COMMUNICATION EQUIPMENT MAINTENANCE BULLETIN

SECTION 9. TRANSMITTING EQUIPMENT

FIGURE 1.—Revised schematic of model TDE.

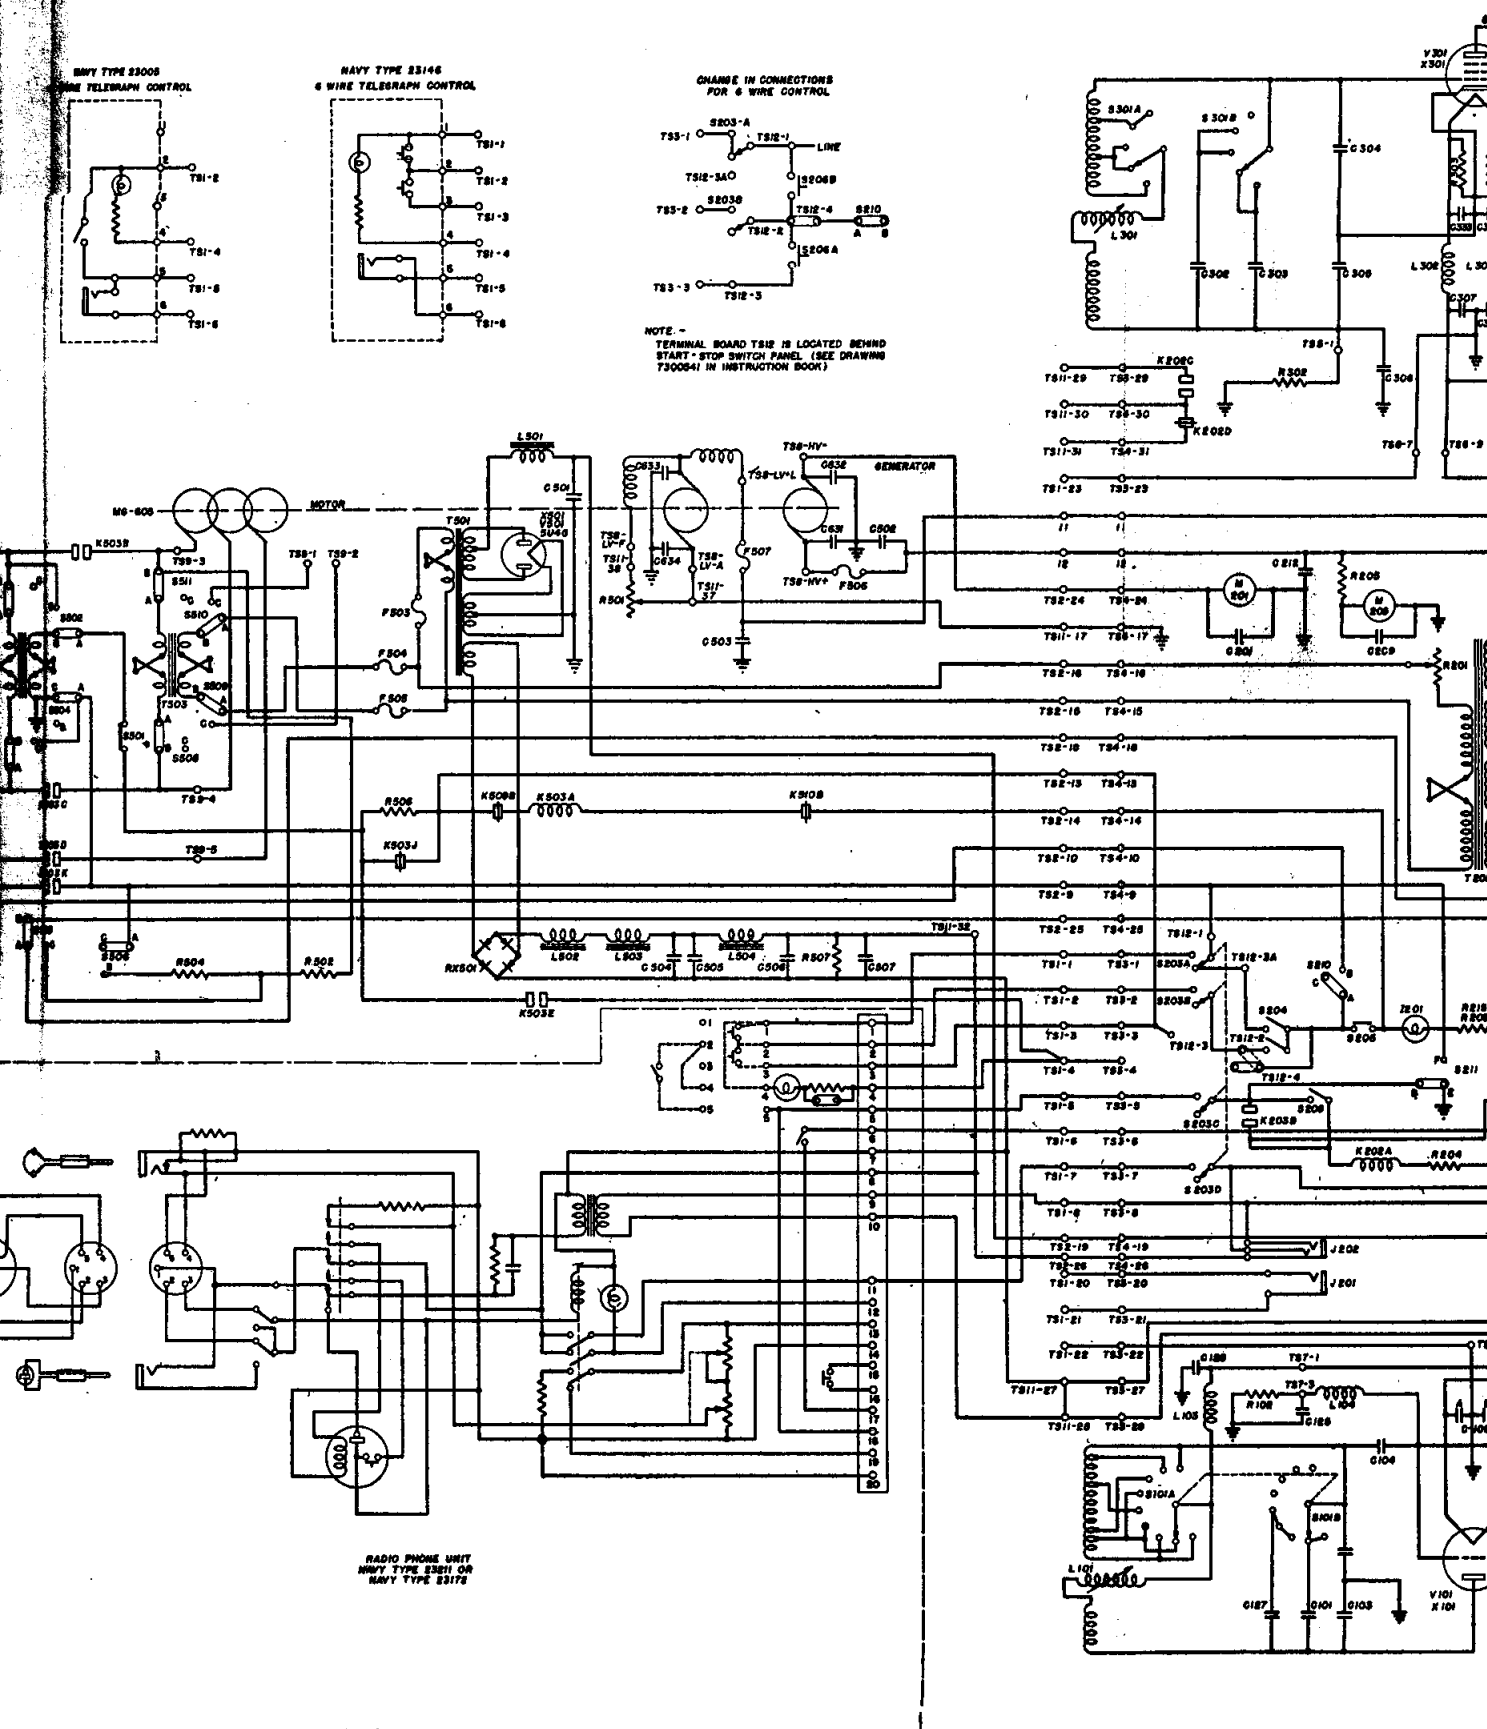
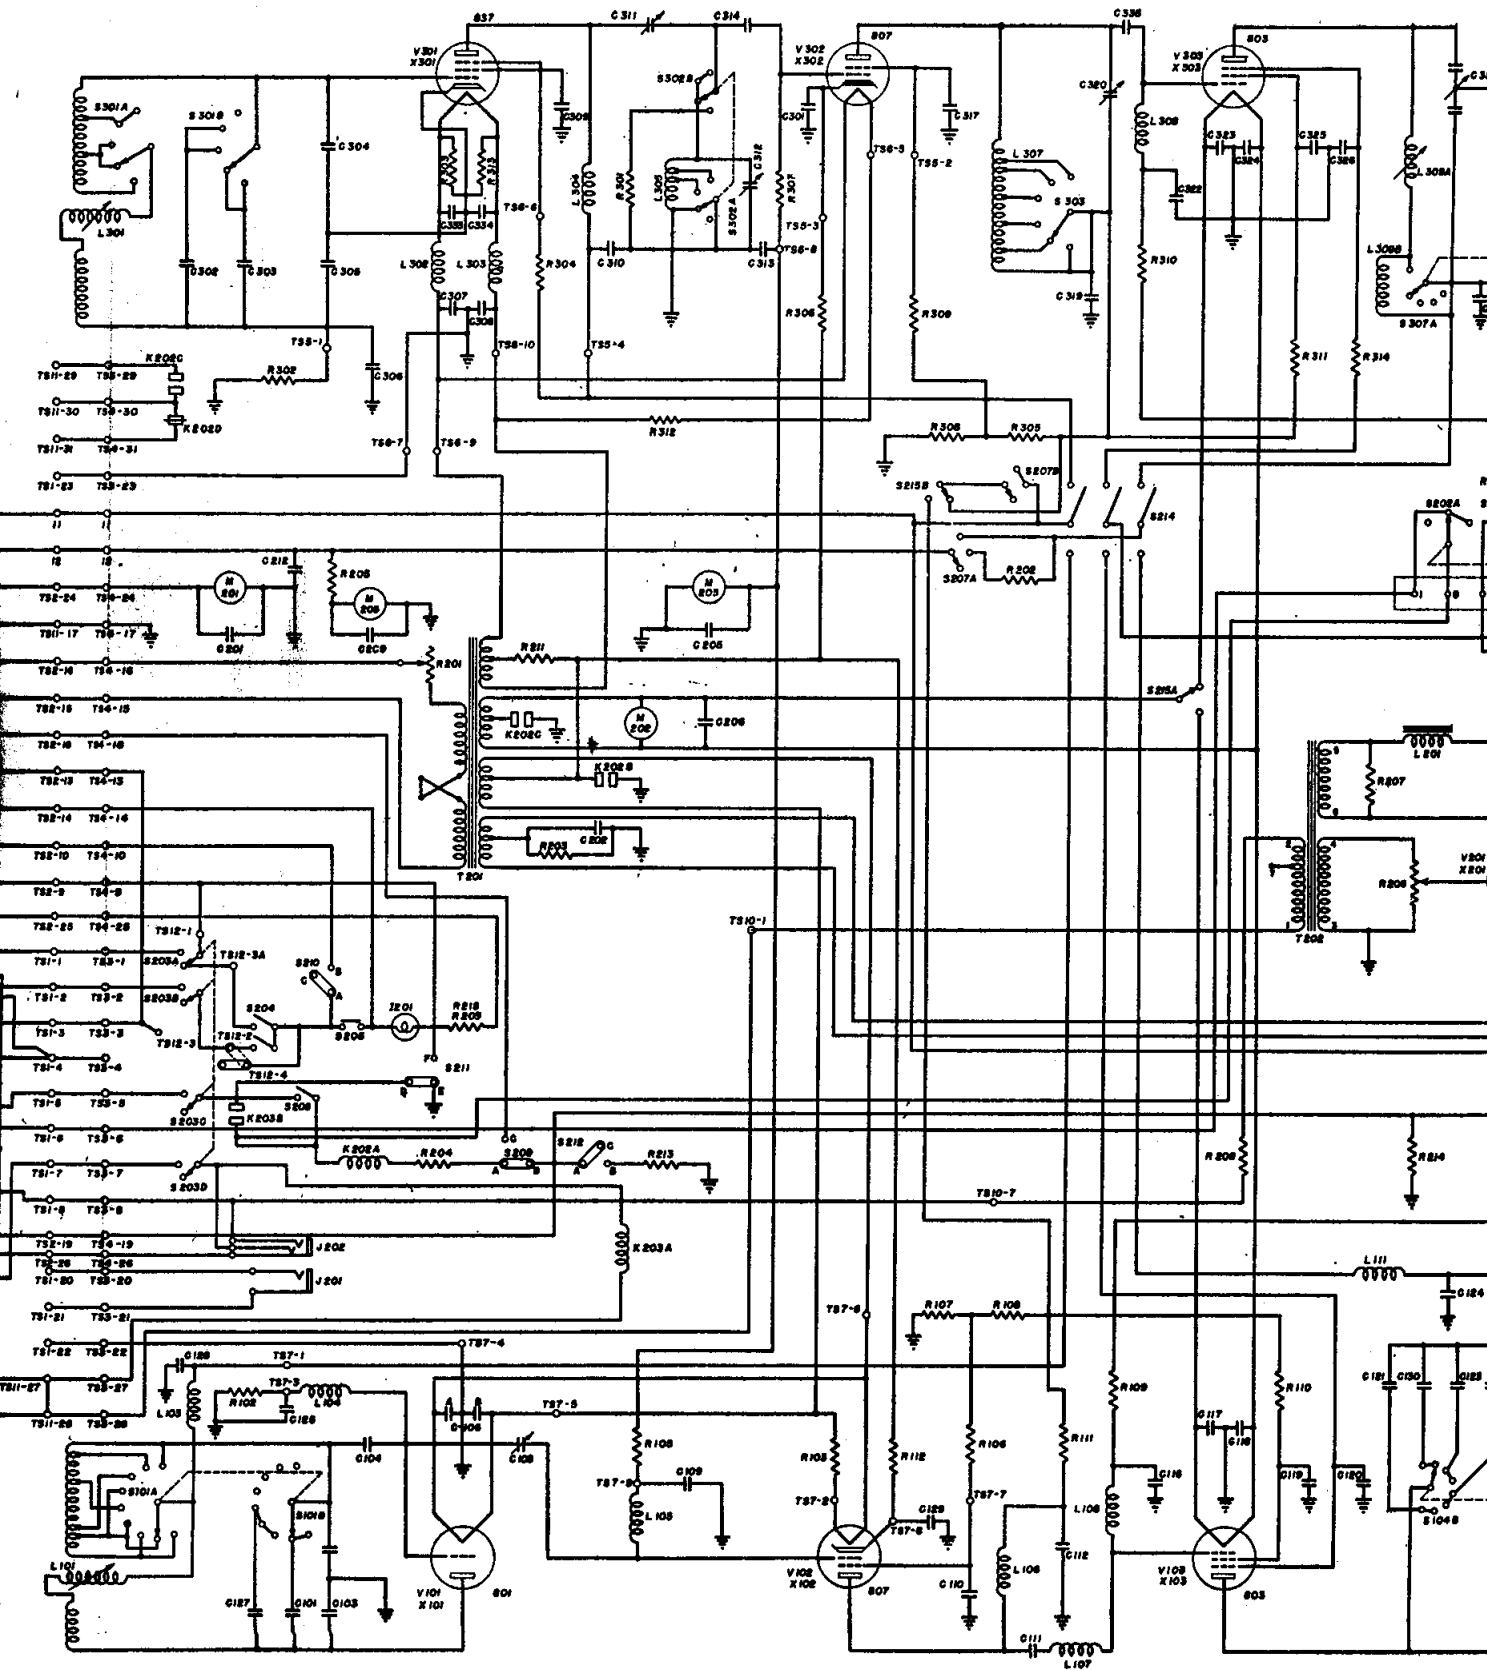
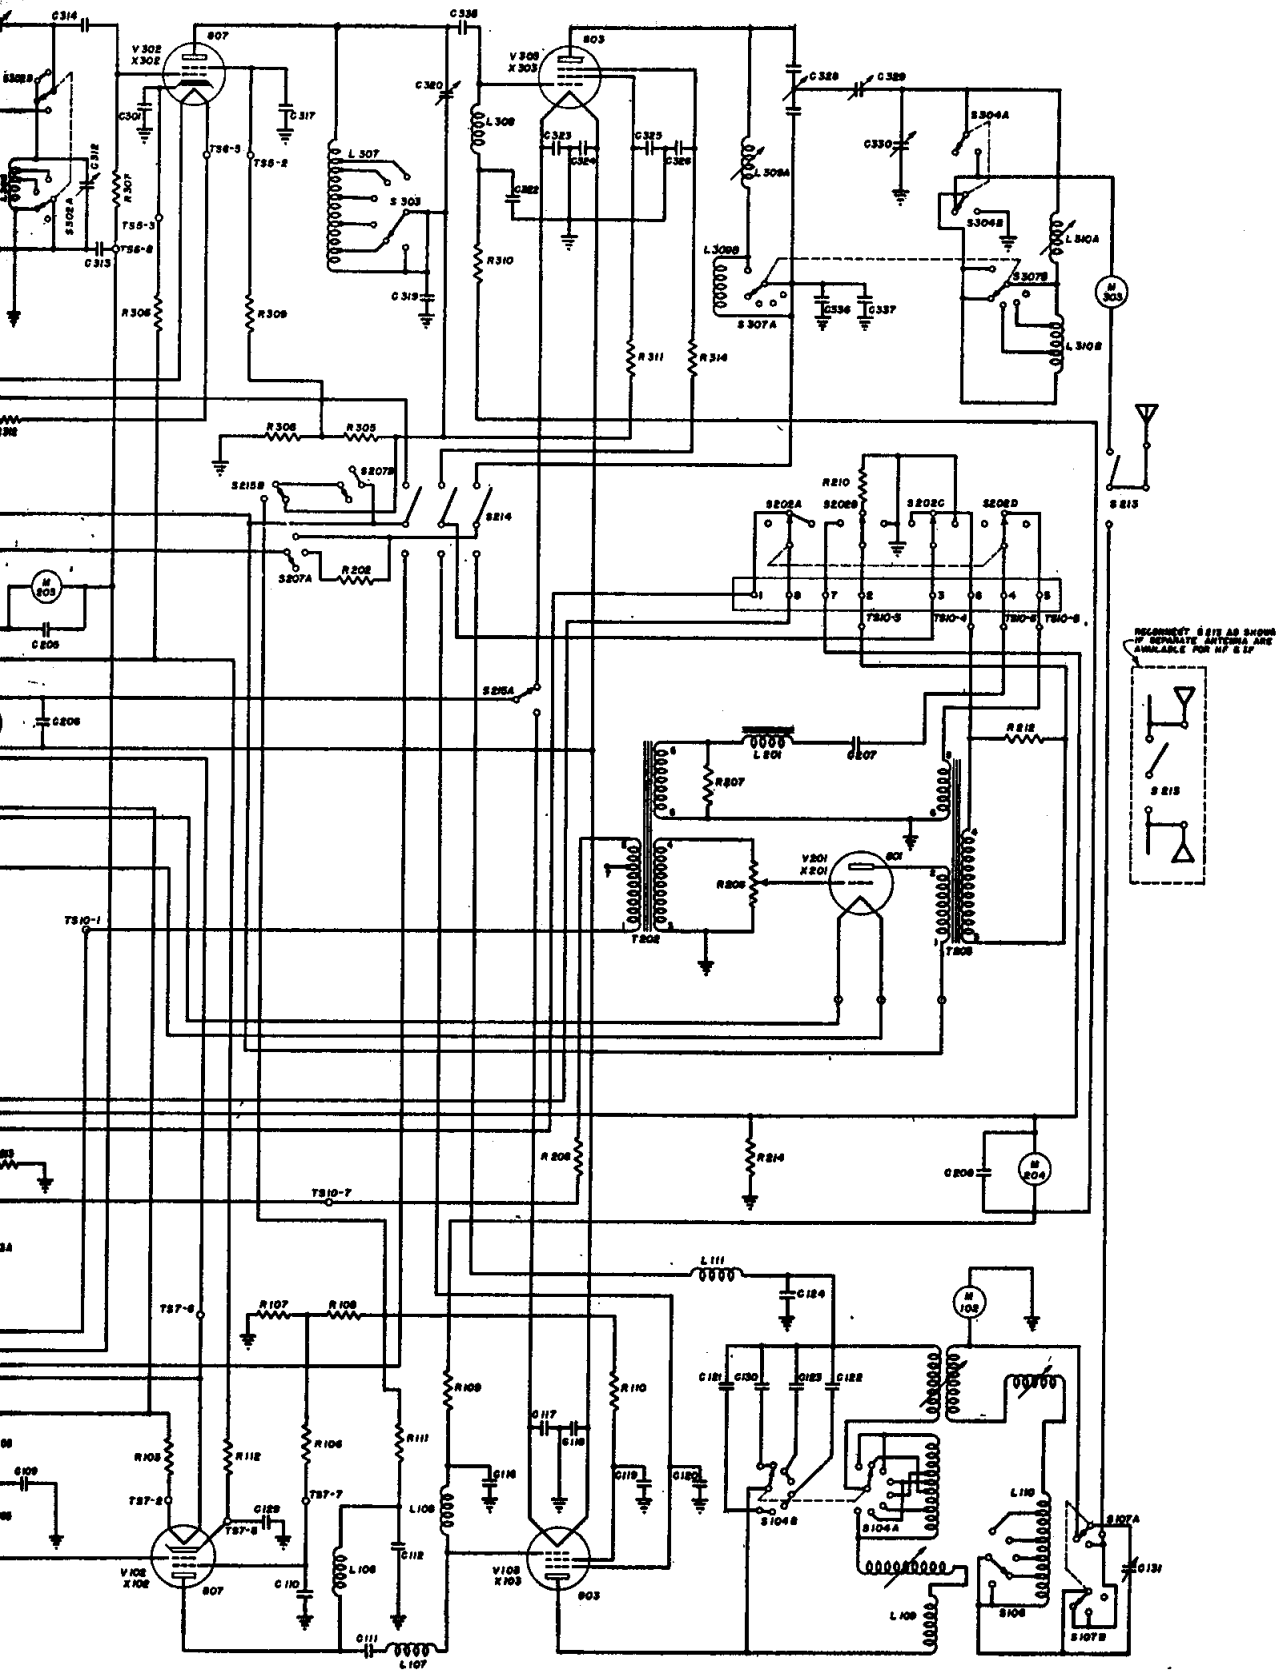
A new schematic is provided in Figure 1. The modification is to be made to transformer T-502 as follows:

Figure 1.—Filament warm-up circuit.

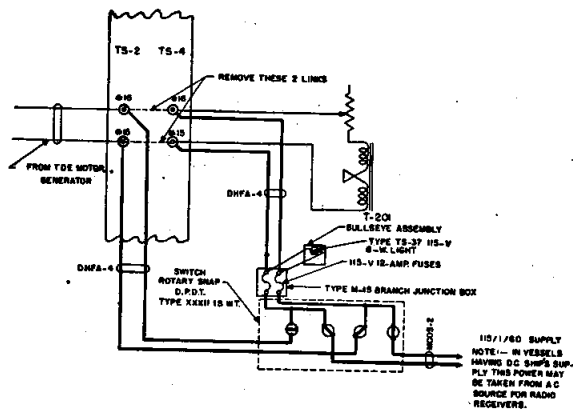
(7) The wiring and cable connections should be made in accordance with Figure 1. All wiring should be made in a manner customary with Naval installations. **NOTE:** In vessels having a-c ship's supply, the 115V/1 ϕ /60 cycle power may be taken from the a-c source for radio receivers.

FIGURE 1.--Circuit for adding variable resistor to bring filament transformer secondary voltage to correct value.

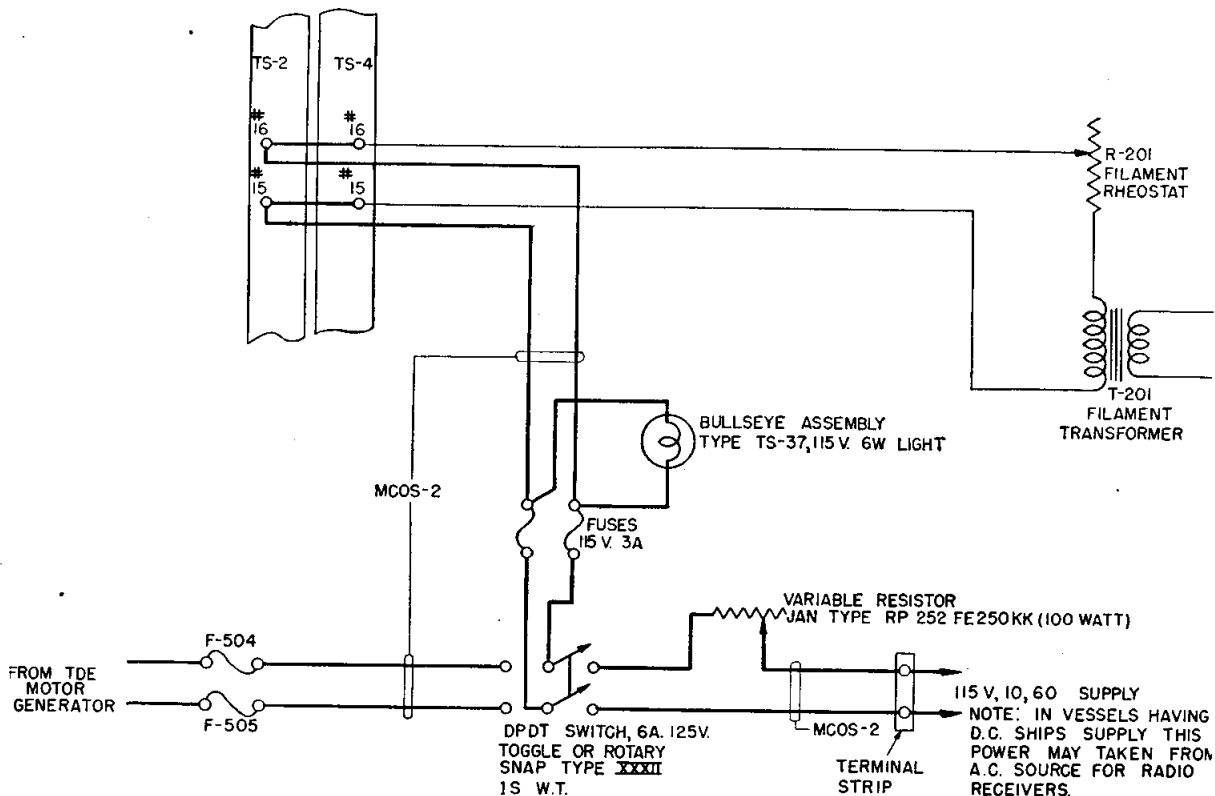
In order to overcome this difficulty, a 25-ohm 100-watt variable resistor should be appropriately installed in the 115-volt single-phase 60-cycle stand-by supply circuit, as shown in Figure 1.

Equipments already modified using previous instructions should not be changed except for the installation of the 25-ohm, 100-watt potentiometer. Equipments which require this change should be modified in accordance with Figure 1.

The instruction book schematic diagrams and parts list should be corrected accordingly. 7/1/48.

FIGURE 1.—Outline of power supply PP-338/U showing location of relay K-101.

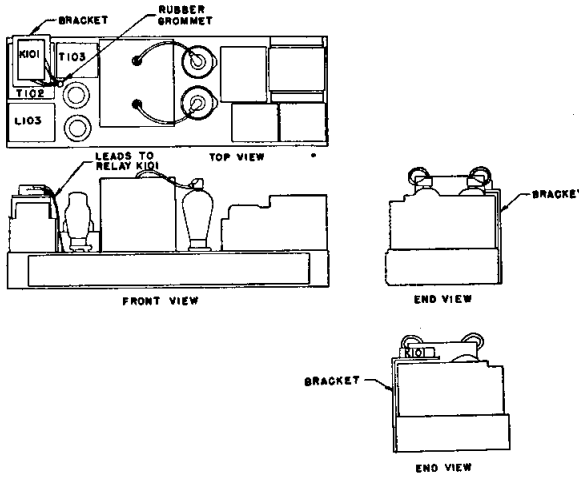
is mounted on the under side of the chassis which renders it extremely difficult to maintain and inspect. Mounting this relay on the upper side of the chassis as shown in Figure 1 will effect a saving of time and personnel in the maintenance and repair of this unit. The modification requires construction and installation of

FIGURE 2.—Dimensions for bracket to mount relay K-101. ←

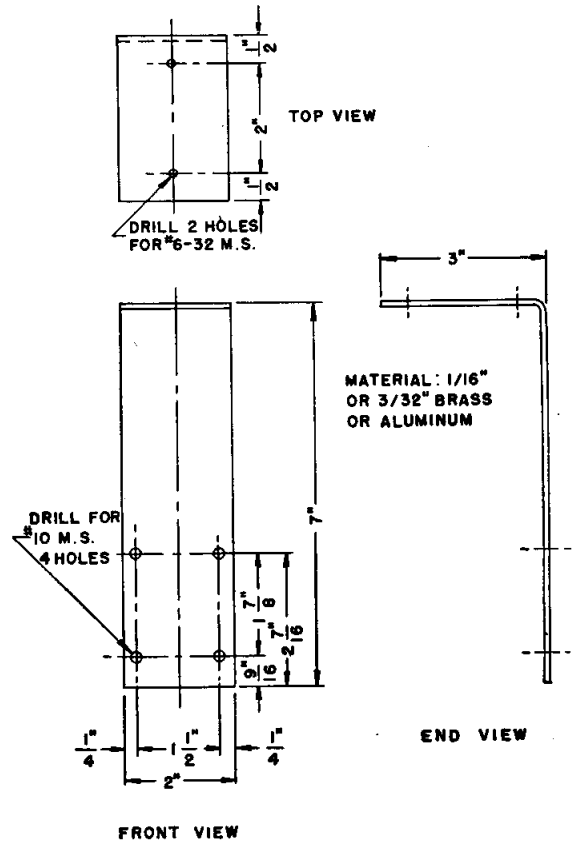
a simple angle bracket, as shown in Figures 1 and 2. The leads to the relay may be brought up through a rubber grommet, as shown in Figure 1. The modification may be performed by Navy Yard personnel using standard stock material. No special tools are required. 1/1/51

FIGURE 1.—Corrected wiring diagram of TDH-4 final amplifier.

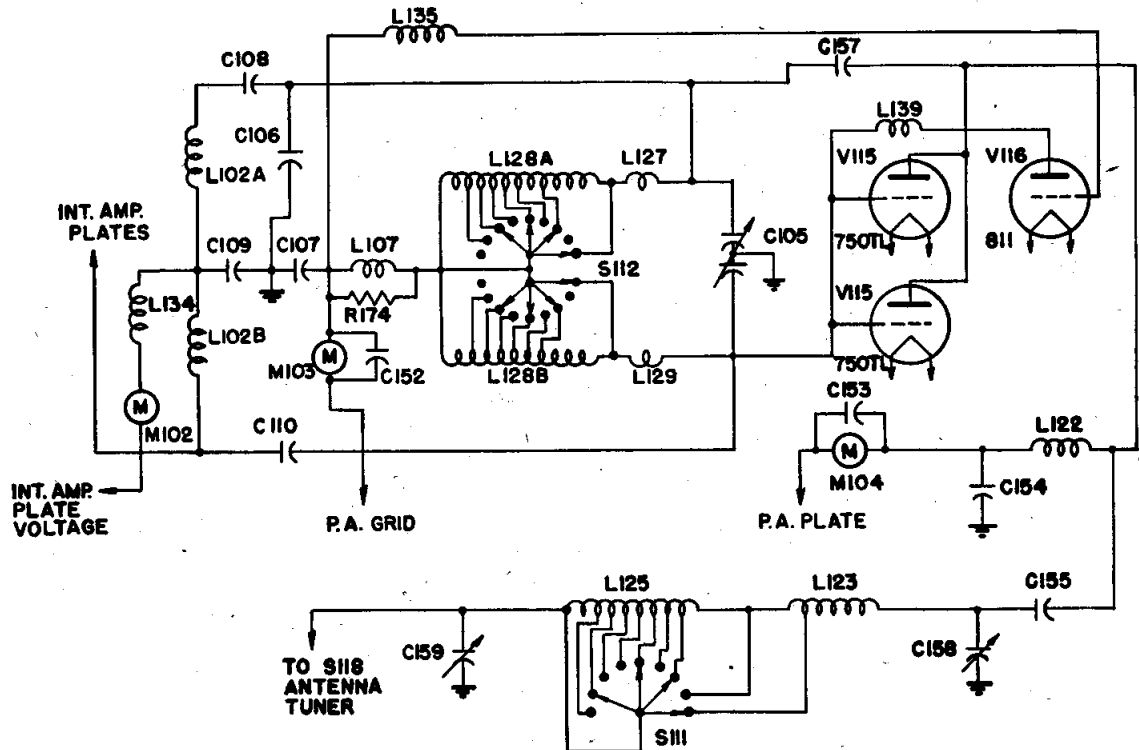
(a) Parasitic damping resistor, symbol R-174, shunted across L-101 was shown on figure 81 but not on figure 82. Further investigation disclosed that this resistor was omitted in the transmitter.

(b) Choke, L-139, is shown between the plate of the power amplifier stabilizing tube V-116 and the power amplifier grids on figure 82 while on figure 81 the plate of the stabilizing tube and the grids of the power amplifier tubes

are directly connected. The transmitters were incorrectly wired, i. e., according to figure 81.

It is requested that all activities receiving model TDH-4 transmitters check the equipment for the above discrepancies. The spare parasitic damping resistor, R-174, contained in the spare parts, should be installed and the power amplifier grid parasitic suppressor choke, L-139 should be rewired and connected as shown on figure 82.

Figure 1 is a corrected diagram of the final amplifier showing the proper placement of components.

FIGURE 1.—Frequency meter connections for model TDN equipment installed in the model MBK trailer.

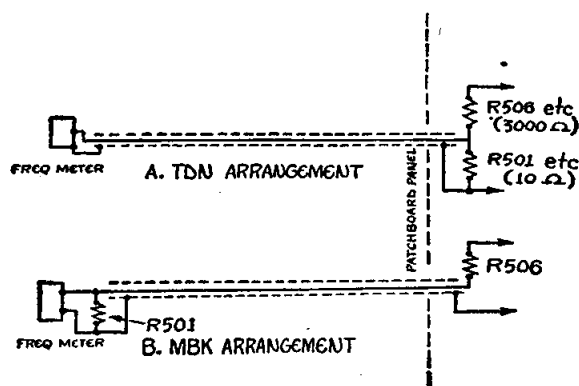
It was found that the difficulty was eliminated by simply connecting the 10-ohm resistor across the receiving end, instead of the sending end of the transmission lines connecting the patch board panel to the frequency meter jacks. Consequently, the MBK trailers are wired in this manner. The change from the TDN to the MBK connection is shown in Figure 1.

FIGURE 1.—Front panel of TDN equipment showing location of crystal adjust capacitor C-1.

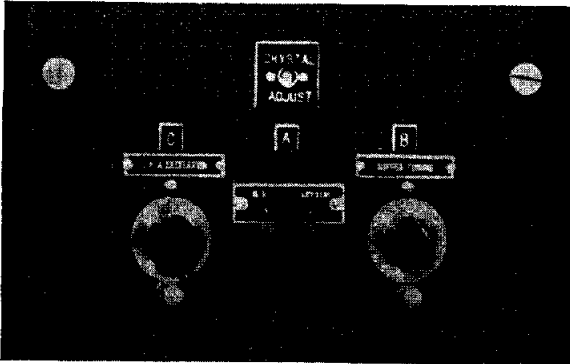
This modification consists of relocating the crystal oscillator control condenser C-1, to the inside of the oscillator compartment front panel as shown in Figure 1. This control is presently installed on the oscillator compartment deck. It is required that three (3) holes be drilled in the front panel as shown in Figure 2. The lead from the crystal socket to C-1 is threaded through a grommet inserted in the shaft hole of the original position of condenser C-1. A ground wire is then installed from C-1 to the crystal socket mounting screw.
